**BEFORE THE ILLINOIS POLLUTION CONTROL BOARD**

PETITION OF BRICKYARD DISPOSAL & )  
RECYCLING, INC. FOR AN ADJUSTED ) AS 14-03  
STANDARD PURSUANT TO 35 ILL. ) (Adjusted Standard - Land)  
ADM. CODE 814.402(B)(3) and FROM 35 )  
ILL. ADM. CODE 810.103, 811.318(b)(3) )  
and 811.320(c) )

**PETITIONER’S RESPONSE TO IEPA RECOMMENDATION**

**ILL 1**

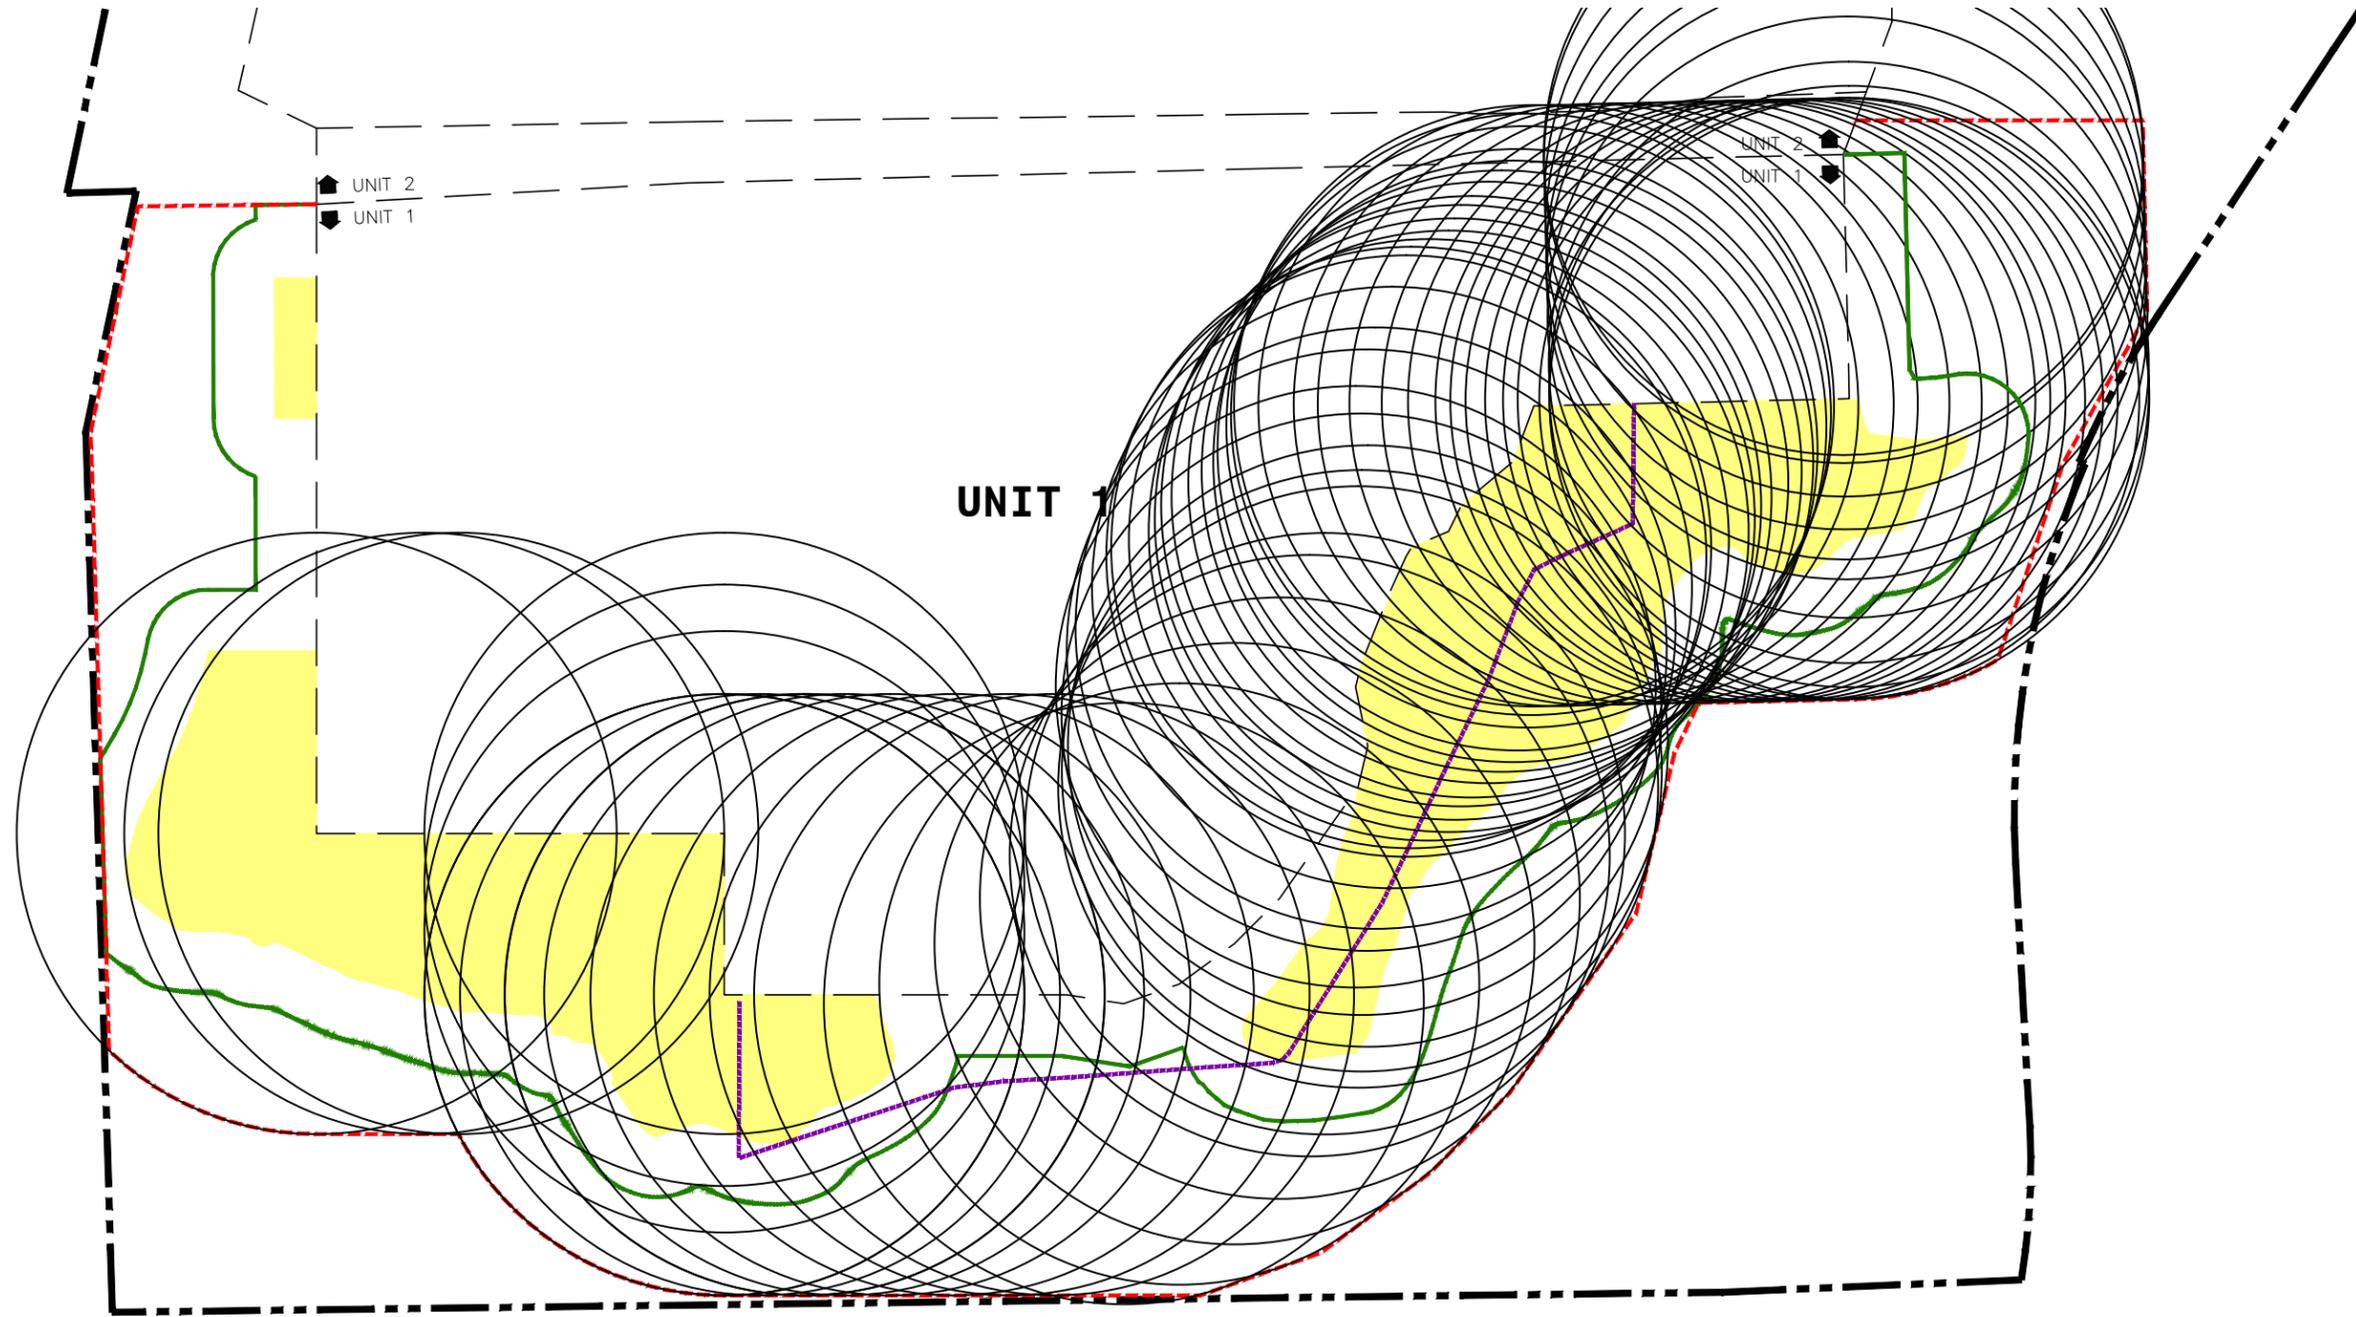
Section 814.402(b)(3)(I) clearly provides that “(N)otwithstanding the limitations of subsection 814.402(b)(3)(H), in no case shall the zone of compliance at an existing MSWLF unit extend beyond 150 meters from the edge of the unit.” In its Recommendation, at paragraphs 65 – 70, IEPA suggests that the compliance boundary proposed by Brickyard does not appear to meet this requirement. It suggests that clarification “will be necessary since, again, the use of the scale at the bottom of Exhibit A, Figure 1 would tend to show that the fill area in at least one location [does not meet this requirement].” Rec., at par. 69.

The proposed compliance boundary was drawn, utilizing Computer Aided Design (“CAD”) technology, with the regulatory maximum distance set forth in Section 814.402(b)(I) (*i.e.*, 150 meters from edge of waste unit) fully known, understood, and respected. The proposed compliance boundary is drawn to be within that maximum compliance boundary, at each and every location. To illustrate this fact, AEI has prepared a map demonstrating how the computer generated the 150 meter distance from the edge of the unit. Specifically, the computer generated the line by taking the edge of the unit, at every point at its outer boundary, and establishing those points as the center point of a series of circles, the radius of which is 150 meters. See Illustration 1. At no point does the proposed compliance boundary, depicted in green, exceed the maximum compliance boundary (*i.e.*, 150 meters from permitted waste unit) as set forth in Section 814.402(b)(I), depicted in red.

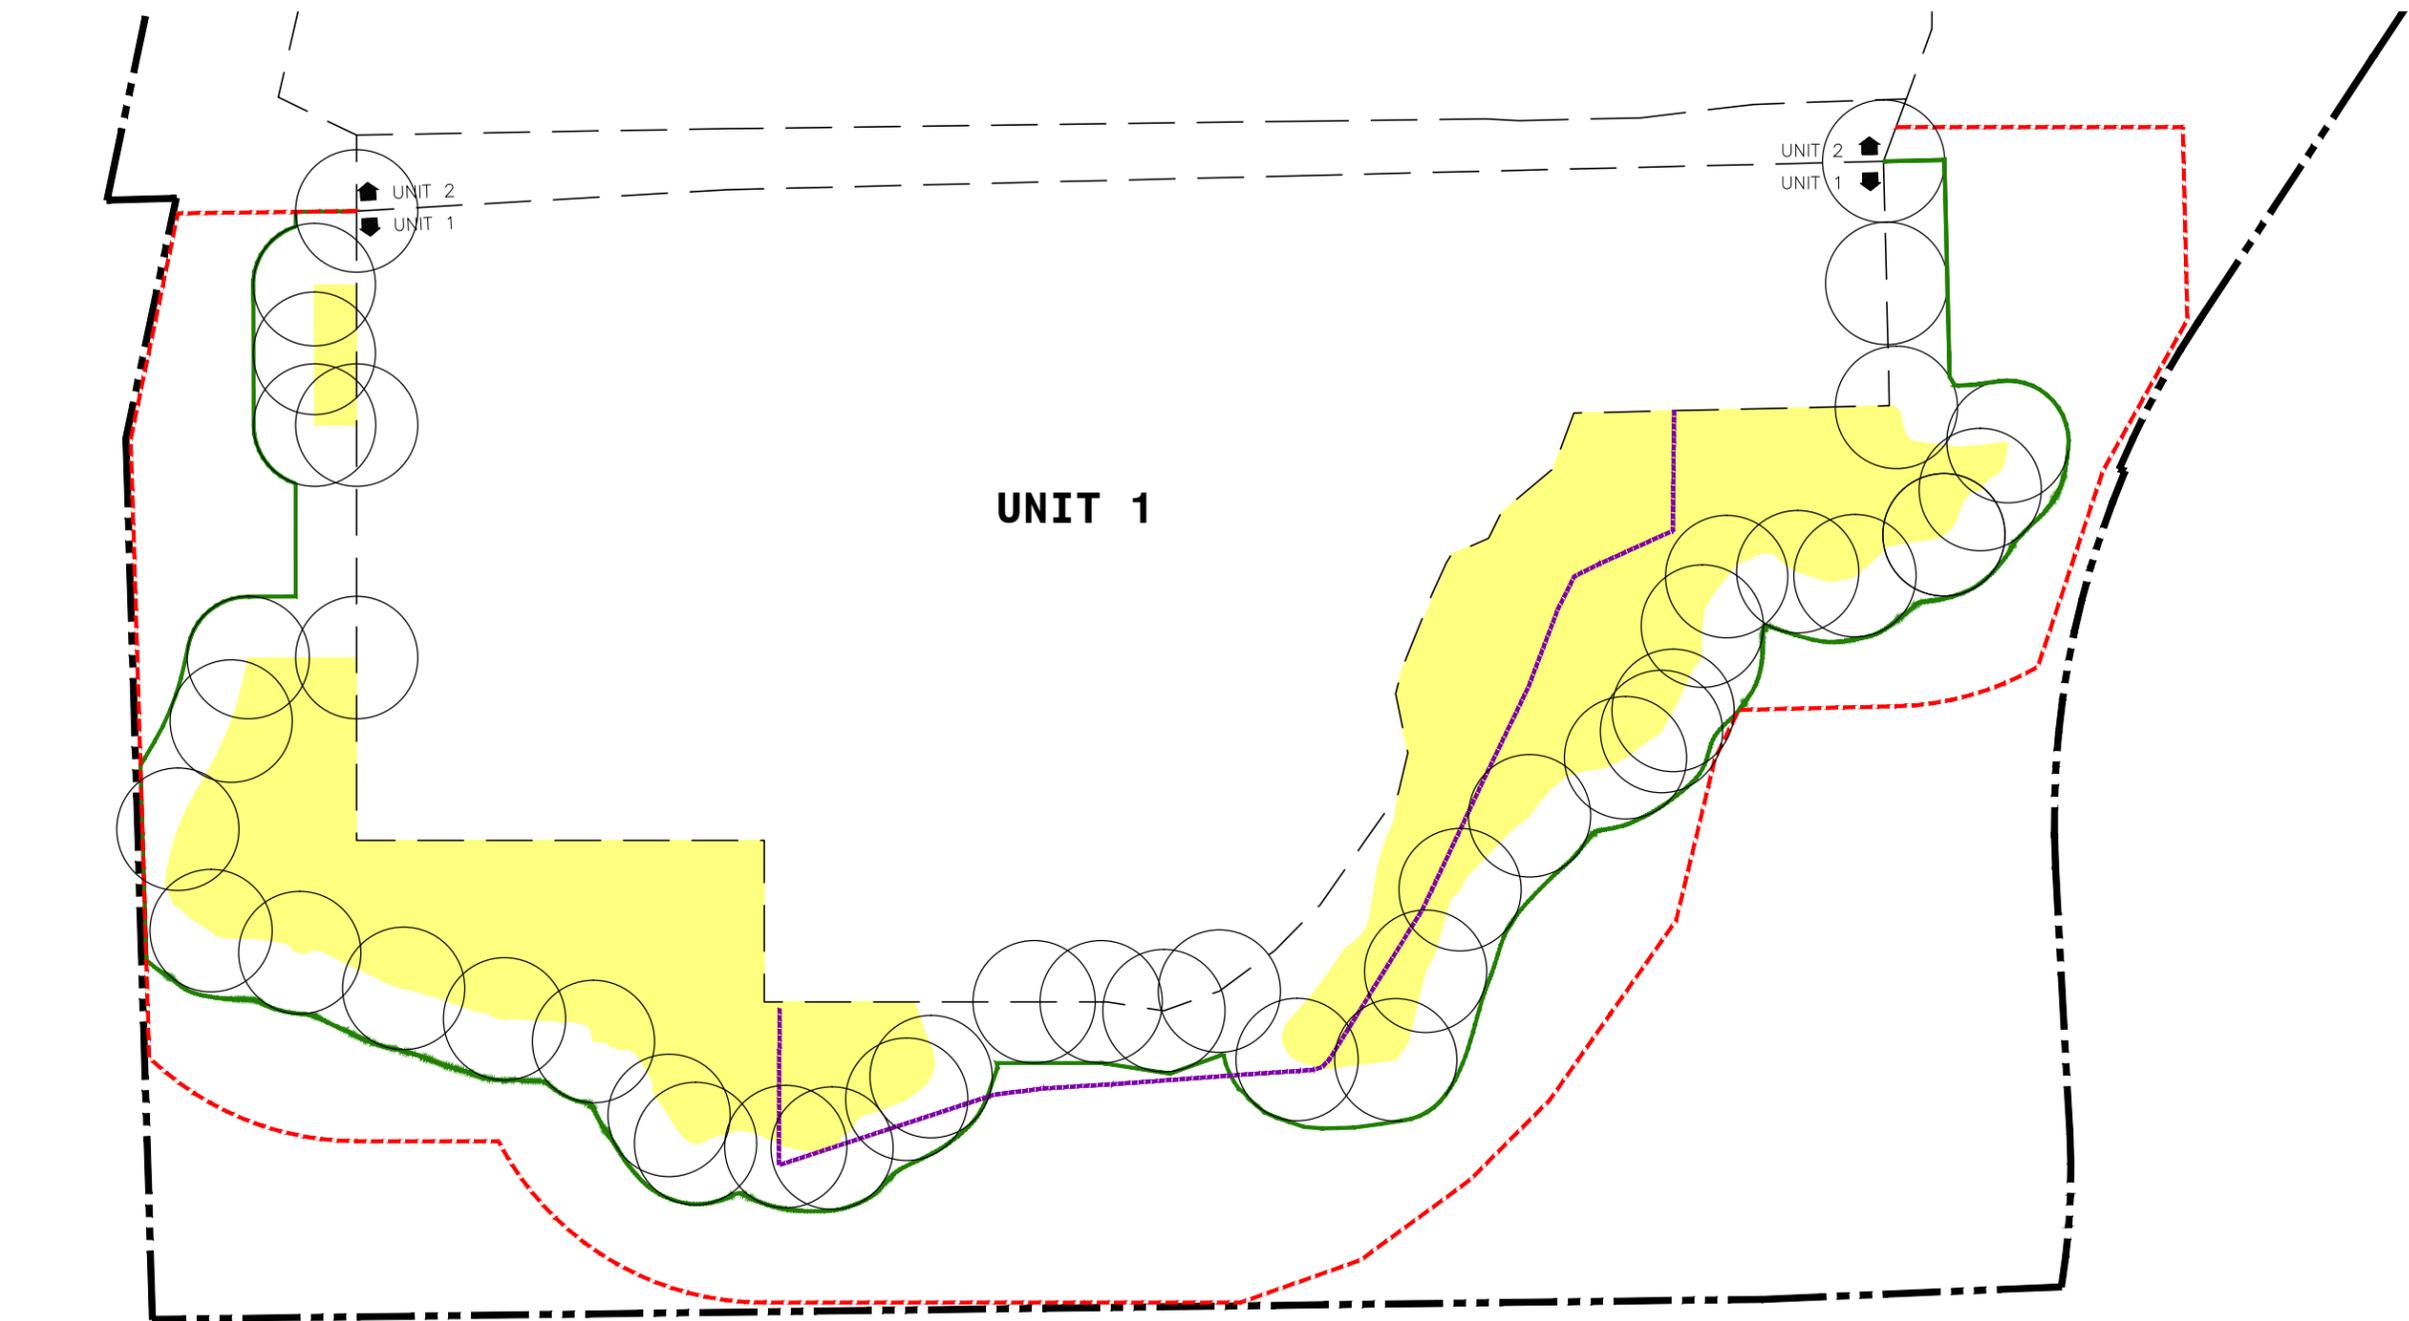
The petition identifies Brickyard's proposed compliance property boundary as 100 foot from either the edge of the waste unit or the edge of the extraneous material area, whichever is relevant. IEPA points out that it is actually greater than 100 foot at the southern end of the landfill and Brickyard agrees that the line was drawn that way in the petition, in order to accommodate an existing permitted Groundwater Management Zone ("GMZ") on the southern edge of the landfill, which is greater than 100 feet from the edge of the unit. Although the petition clearly shows this area (Pet. Exh. A, Figure 1), Brickyard here addresses that issue further, and revises to accommodate the IEPA's request, in Section IV.B.2, below.

Further, while the line was drawn greater than 100 feet only in relation to the GMZ, it actually is less than 100 feet in two discreet areas. First, the compliance boundary at the western side of the property is less than 100 feet because the proposed compliance boundary is limited by the property boundary, consistent with Section 814.402(b)(H), as the property boundary in that location is less than 100 foot from the edge of the extraneous material.<sup>7</sup> Second, the compliance boundary is slightly less than 100 feet in an area on the eastern side of the landfill property,

because it is restricted by Section 814.402(b)(I) (*i.e.*, 150 meters from edge of waste unit). Similar to Illustration 1, which addresses compliance with Section 814.402(b)(I) as it did with the 150 meter restriction prohibition, discussed above and illustrated in Illustration 1, AEI drew the 100 foot compliance boundary utilizing CAD technology. A visual depiction of how that line was generally drawn at 100 foot, but less than 100 feet in the two areas referenced above, is set forth in Illustration 2. *See* also Exh. A, Figure 1.

DATE: AUGUST 2014  
 PROJECT ID: 1989-115A  
 SHEET NUMBER:  
**ILL 3**

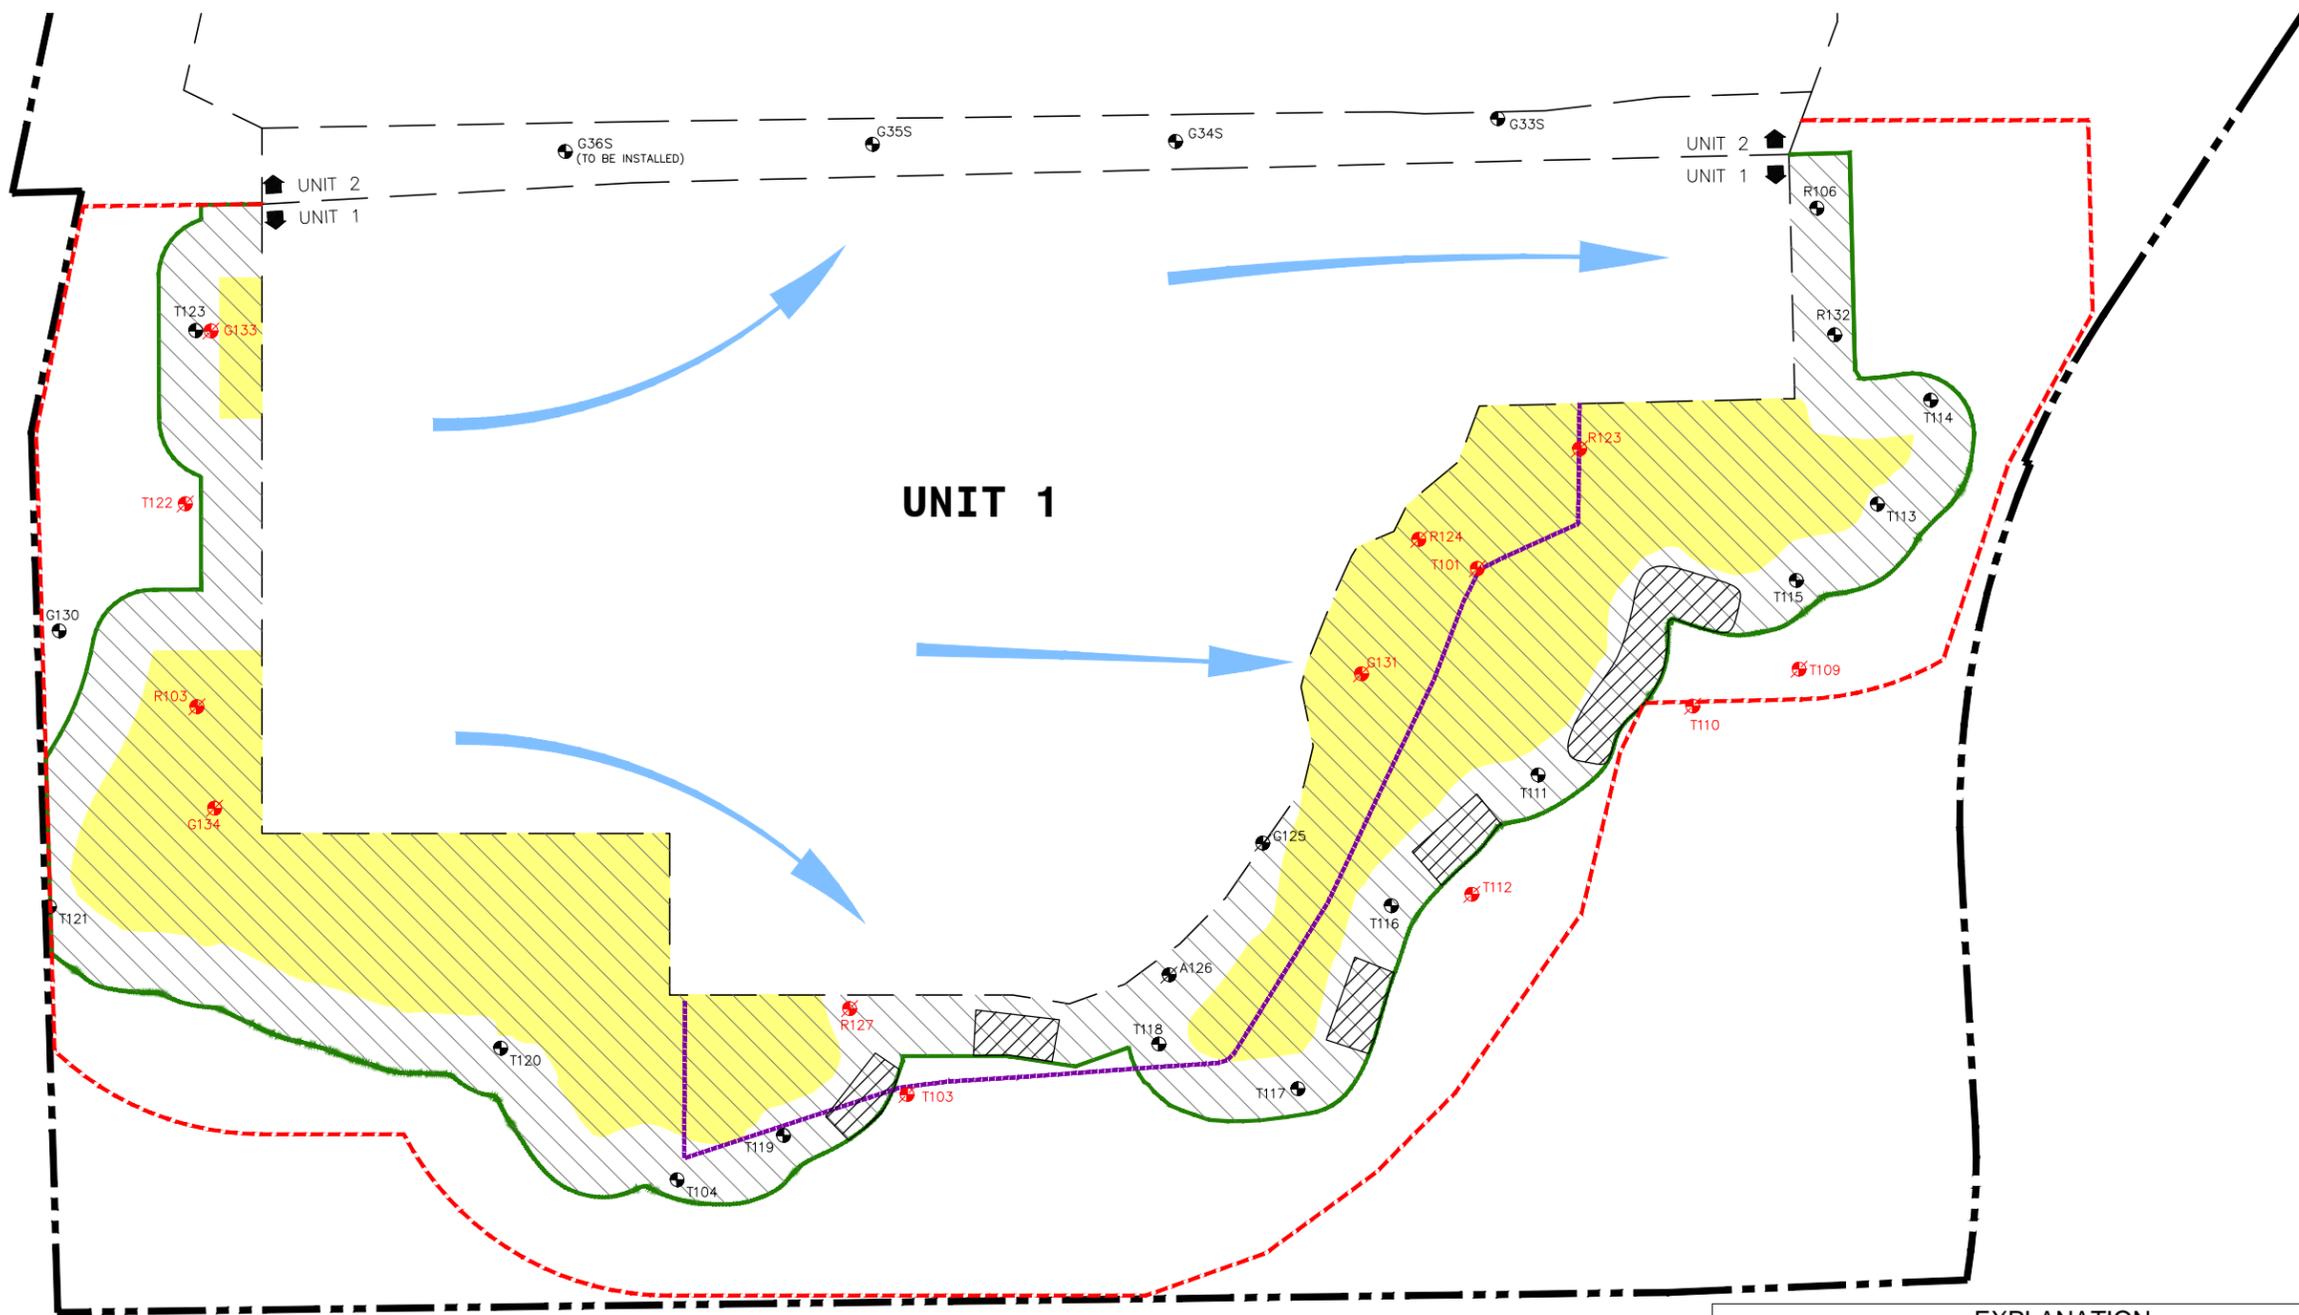
The IEPA also correctly points out that the petition requests that the compliance boundary be extended, and a zone of attenuation established, even in the specific areas where there is no extraneous material. See Rec. pars. 49 – 52. The IEPA's criticism is not technical in nature, but suggests (incorrectly Brickyard believes) that the petition did not provide any

First, Brickyard had no idea that this point would draw IEPA criticism since the currently permitted groundwater monitoring network *includes* existing permitted wells in areas where there is no extraneous material, and yet are not placed at the unit's edge. Brickyard hopes to retain these as part of the permanent routine monitoring network. See attached Illustration 3 (*i.e.*, wells R106 and R132).

In that vein, AEI has prepared Illustration 3 (Res. Ill. 3), which presents the Board with a picture of what Brickyard expects to occur in permitting, if it grants this adjusted standard. Specifically, in its permit application to the IEPA, Brickyard will place all downgradient wells as close to the relevant waste source as possible (unit boundary or extraneous material edge), and within the compliance boundary and zone of attenuation.<sup>8</sup> All currently permitted wells which Brickyard would expect to retain as part of the routine monitor network are shown in black. The areas identified by black lines represent areas where Brickyard expects to develop a new well. One of these new well locations will contain a well that meets the objectives of Section 811.318(b)(5) and, thus, Brickyard does not seek adjustment from that provision. All wells identified in red will likely be retained, but not as part of the routine monitoring network. The above proposed locations of the final routine monitoring network are subject to appropriate modeling and, of course, IEPA permitting.
